DATE RECEIVED <u>July 5, 1995</u>	By: <u>SW</u> (Initials)	PERMIT NUMBER	ACT/015/004
Title of Proposal: <u>Sediment Pond Removal</u>		PERMIT CHANGE #	<u>95 B</u>
Description: <u>Sediment Pond Removal</u>		PERMITTEE	MOUNTAIN COAL COMPANY
		MINE NAME	HUNTINGTON CANYON #4 MINE

APPENDIX 10
SEDIMENT POND REMOVAL
FOR
PHASE II BOND RELEASE

Re: Proposed Sediment Pond Removal
Mountain Coal Co.
Huntington Canyon No. 4 Mine
INA/015/004
Emery County, Utah

TO: Joe Helfrich, Inspection and Amendment Supervisor
FROM: Sharon Falvey, Senior Reclamation Hydrologist *SJF*
RE: Proposed Sediment Pond Removal, Mountain Coal Company, Huntington #4 Mine, ACT/015/004-95B, Emery County, Utah

PROPOSED RIP-RAP APRON

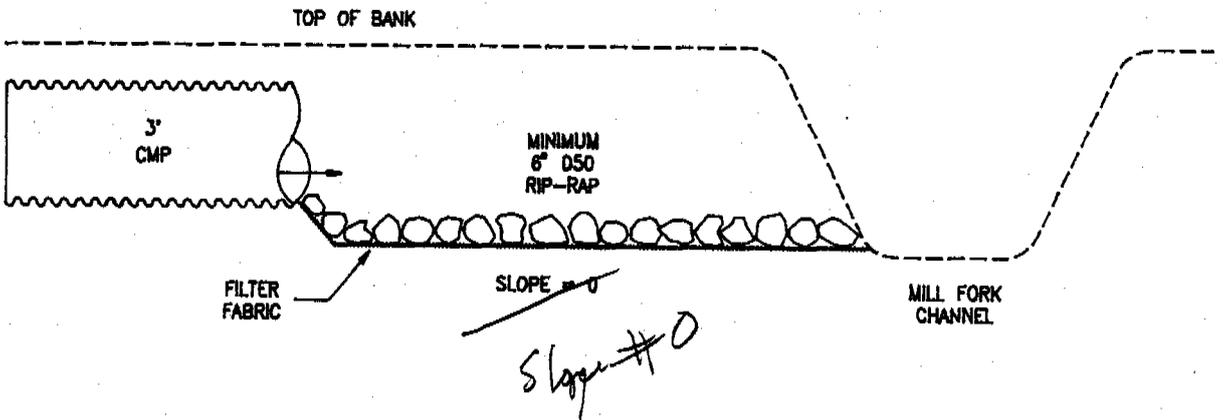
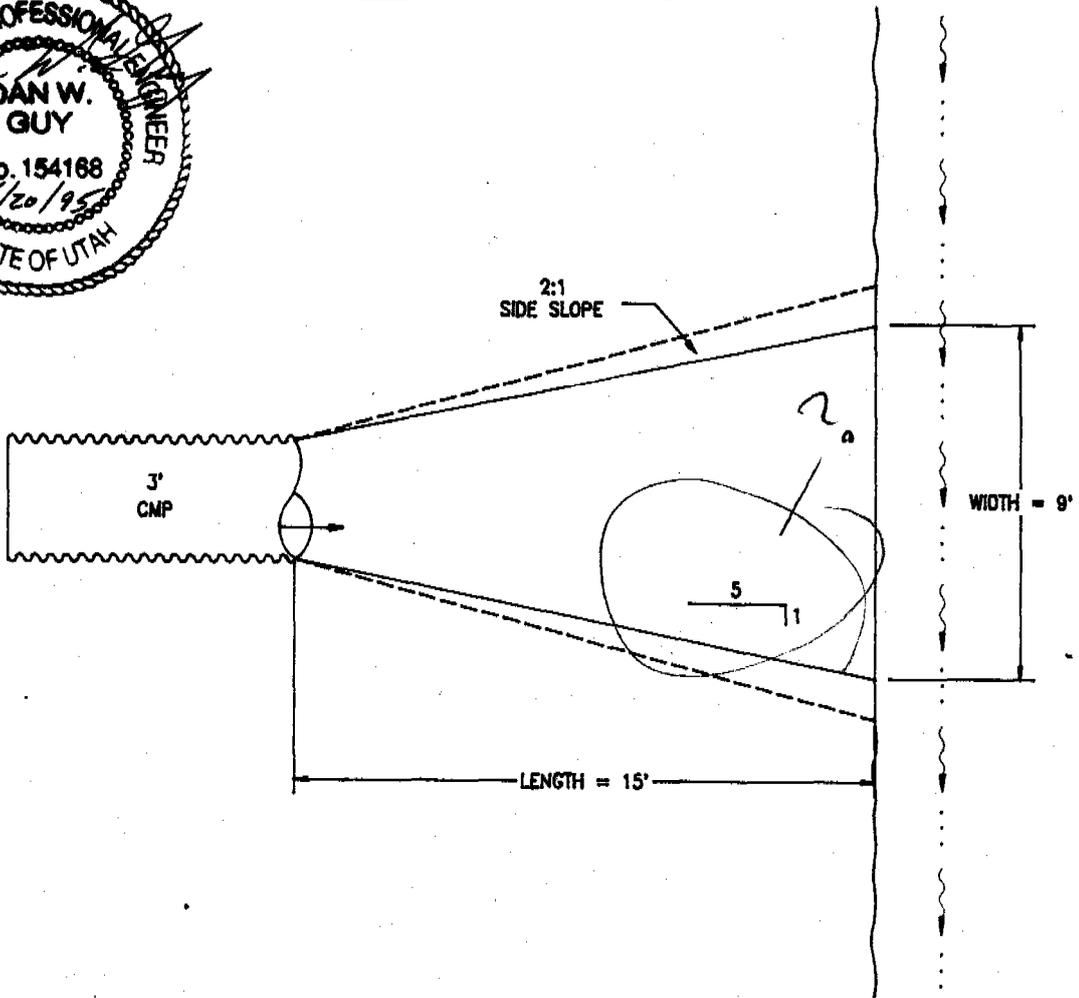
The Permittee proposes the 36" culvert outlet be protected using an energy dissipation apron. The design is based on a method identified in Barfield Warner and Hann, developed by the EPA for 0 % outslope and a tail water depth greater than half the diameter of the culvert ($TW \geq .5 D$). This method assumes the culvert is flowing full. It is not clear whether the proposed design uses the discharge through a 2.38 ft culvert flowing full which is equal to the 100 year-6 hour discharge, or discharge flowing full through a 3 foot culvert.

It appears the Permittee has presented a minimized design based on conditions of $TW \geq .5 D$. However, a condition of $TW \leq .5 D$ more likely to occur in ephemeral systems before equilibrium is reached. The following design deminsions were determined by the Division for a culvert flowing full that is slightly smaller than that carrying the design flow and the proposed culvert flowing full.

Culvert Diameter/Apron Design	27"D/length of apron	27"D/width of apron	30"D/length of apron	30"D/ width of apron
$TW \geq .5 D$	21'	10.7'	27'	13.8'
$TW \leq .5 D$	18'	10.2'	22'	25'

For $TW \leq .5 D$, the Permittee's proposed design length is 15', the proposed design width is 9', and the proposed D50 is 6 inches. The Permittee has provided a conservative design flow but has minimized the energy dissipation apron design. The maximum velocity expected from the 34.12 cfs discharged through a 2.38 ft (28.5 inch) culvert flowing full would equal the 100 year-6 hour discharge with a velocity of 7.82 fps. The same discharge flowing through a 3 foot culvert would however discharge at greater velocity of 9.3 fps.

It is recommended this proposal be approved. The Permittee should consider increasing the length and width of the energy dissipation apron. The Forest Service has deemed the proposal acceptable in the memo received at the Division on August 2, 1995. The Permittee however, resubmitted this plan for approval on August 2, 1995. The approval letter received from the Forest Service did not indicate the recent changes were acceptable. Since the changes in the August 2, 1995 proposal are not significantly different from the original proposal, it is not expected that the Forest Service will have any additional comments. Prior to approval the Division should provide documentation of the Forest Service acceptance for the most recent changes through phone communication or approval letter. A response was requested on August 7, 1995.
